# CERTIFICATE OF APPROPRIATENESS PLACARD

Enclose existing rear porch and add 3 skylights; replace asphalt shingle and membrane roofs; install roof vents; replace/add gutters; install new wood front door and wall sconce lights; install rear wall lighting; remove non-historic secondary front door and wall sconce light; infill/restore original front window opening and install relocated rear historic window; construct new rear wood French doors; remove non-historic HVAC window units; install front porch ceiling fan

209 Linden Ave

COA-0091-2023

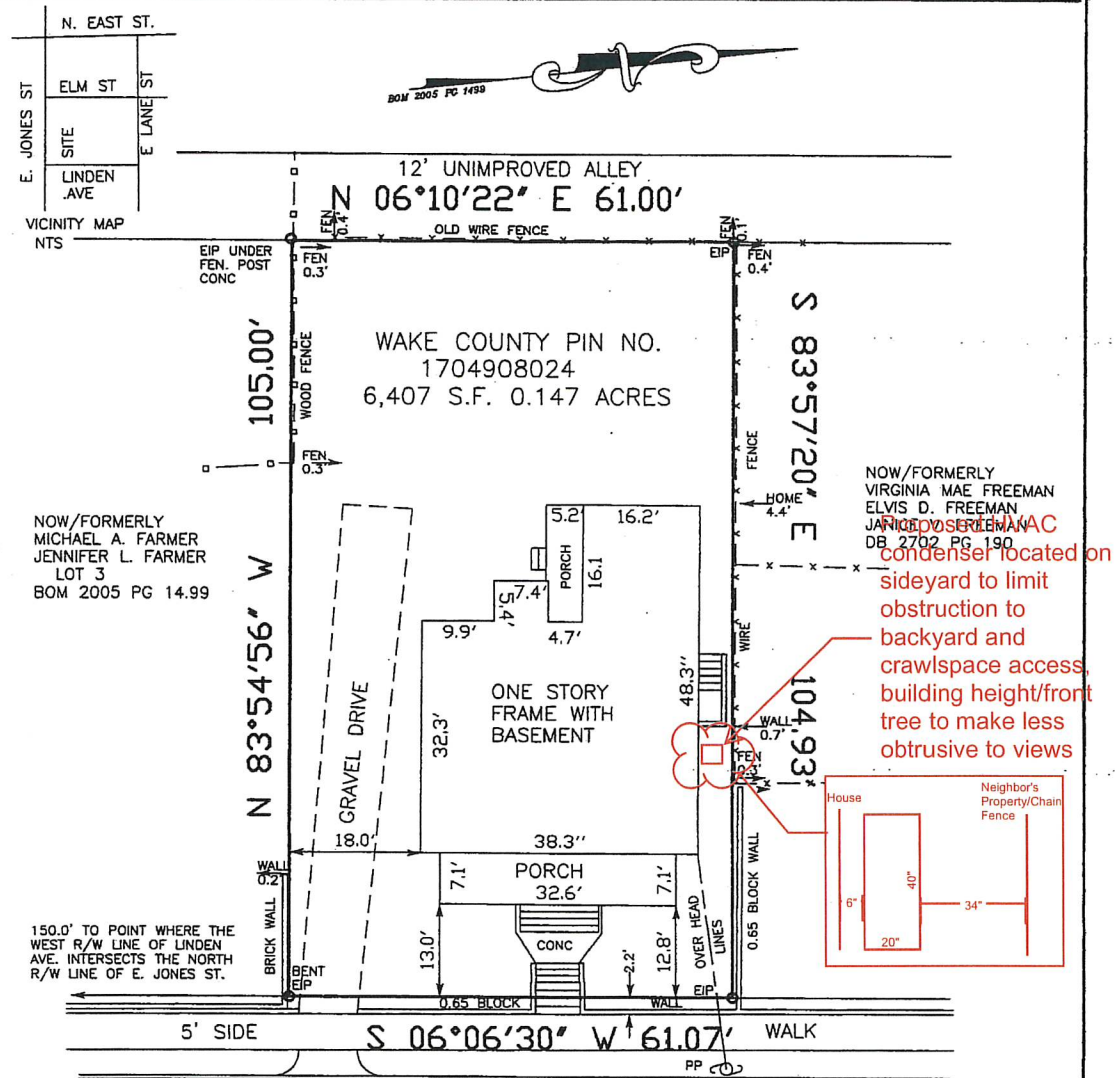
While removing both points of entry from the home, we decided that we'd like to swap out the non-historic door on the front porch with the window from the back left of the home and install a new double door on the rear of the home, centered between the existing bumpout and the left exterior wall. The door will be 72"W x 80"H, with a 16" transom above.

The rear door will be custom built to have matching trim and jambs to match the front entry door.

Daikin Fit, Side Discharge Inverter AC, 16.2 SEER2, 3.0T  
DX6VSS3610

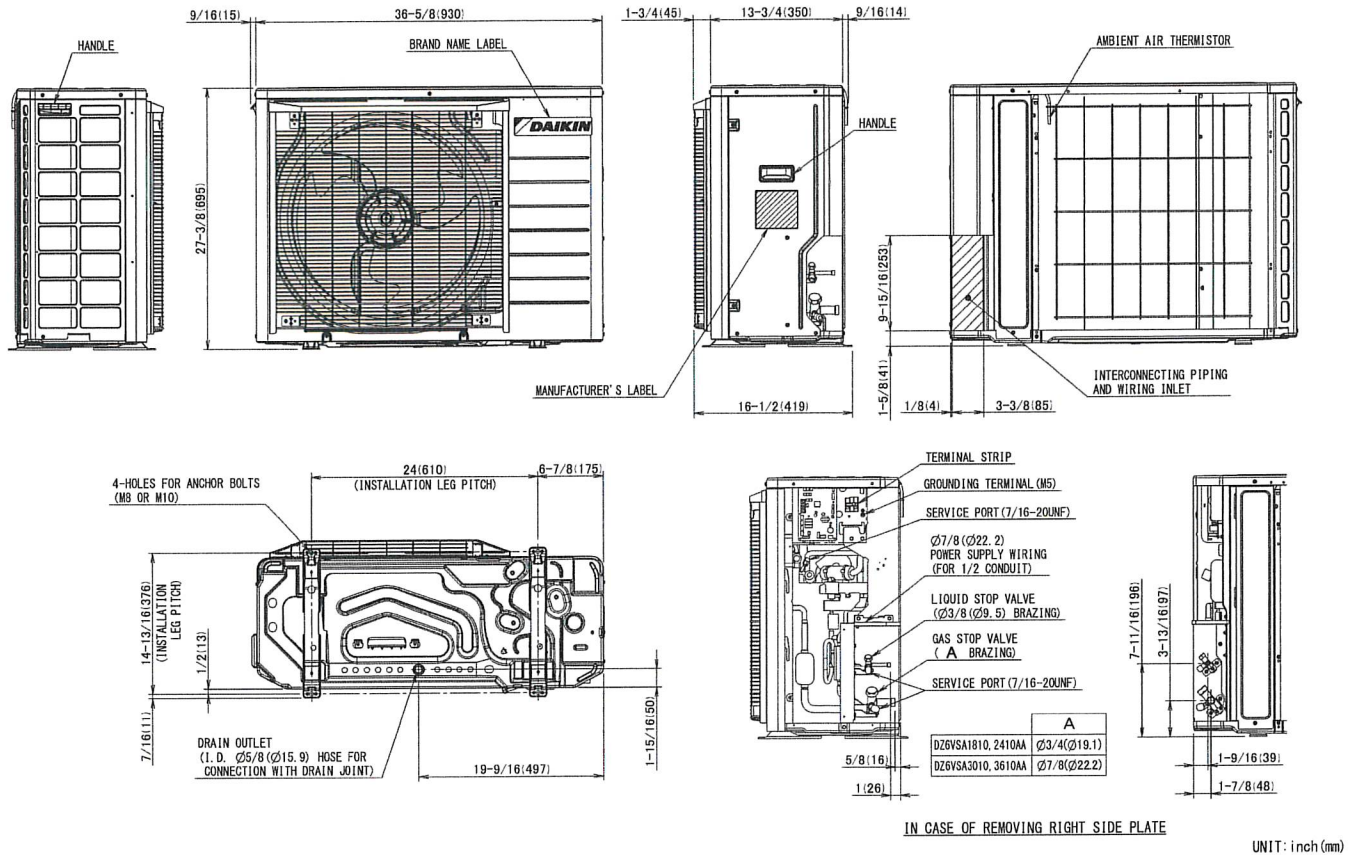
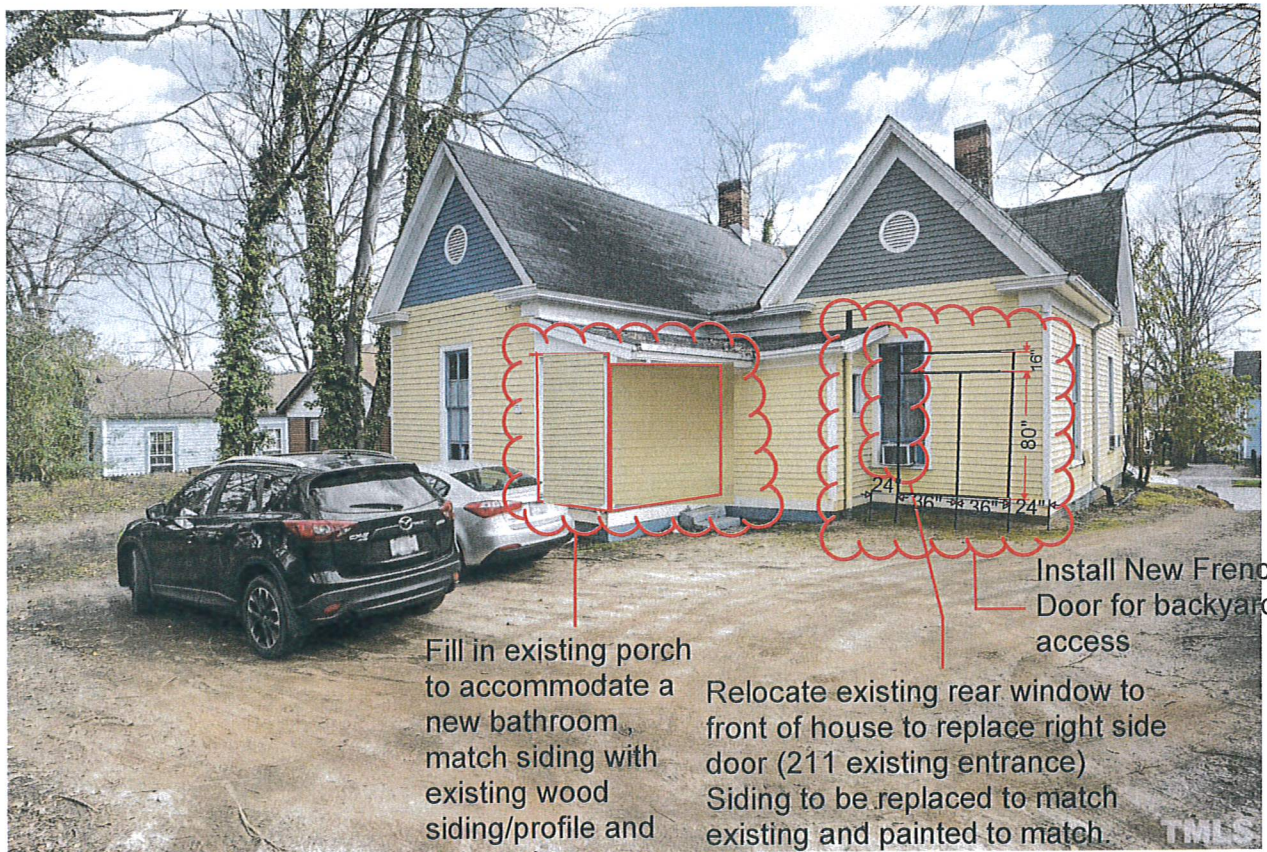
- Please see attached, the membrane is the same color in the back, we will be going back with black in both areas as well.
  - Provide the HVAC unit manufacturer's specifications, including product image, color, overall dimensions, and concrete pad dimensions if constructing (how far off house foundation/wall and how far from side property line?)

- See attached for submittal data on ODU that includes an image of the unit. The pad will be 20"x40", 6" off of the house, and 34" from the neighboring property. See attached revised detail to show this.

Add three 22.5"x46.5"  
curb mounted skylights  
to porch enclosure to  
provide natural light to  
bathroom

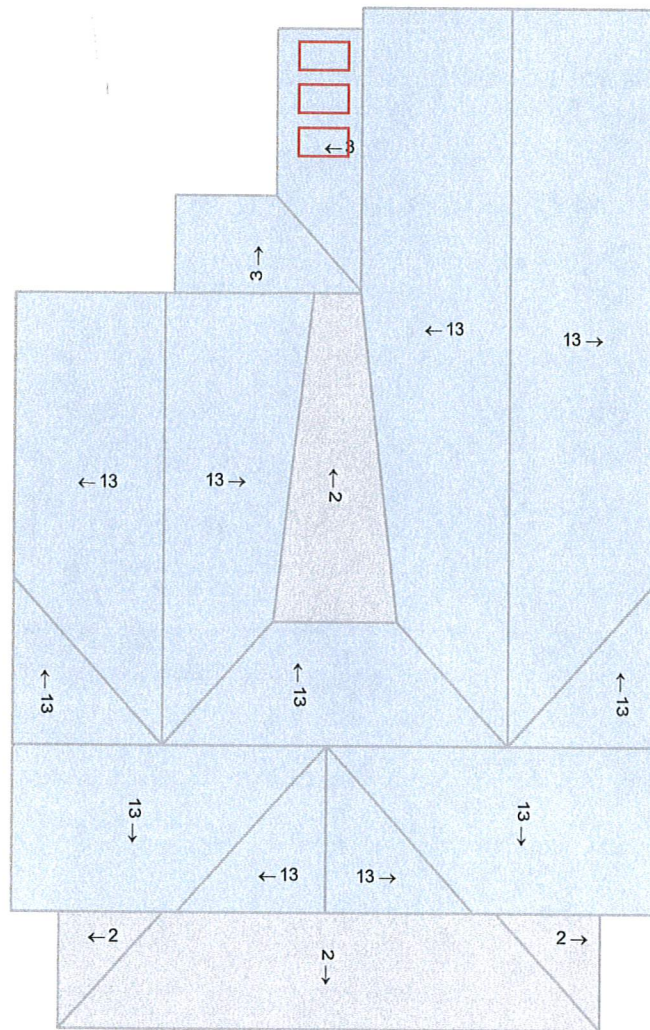
- The application states the skylights will be curb mounted – what is the overall height the skylights will be installed above the roof surface? What is the proposed curb material/color? Ideally, the overall height would not exceed 6" above the roof surface.

- Unfortunately I cannot find a height dimension on the skylight itself, but the curb will be made of 2x4, so will be 3.5" off the roof deck. The depth of the window is 3", but looks like half of that is the "flange" that will go over the curb, so finished install height should be <6". The flashing that goes around the windows is the same color as the frame, unfortunately I can't find where they publish that color but picture can be found here:
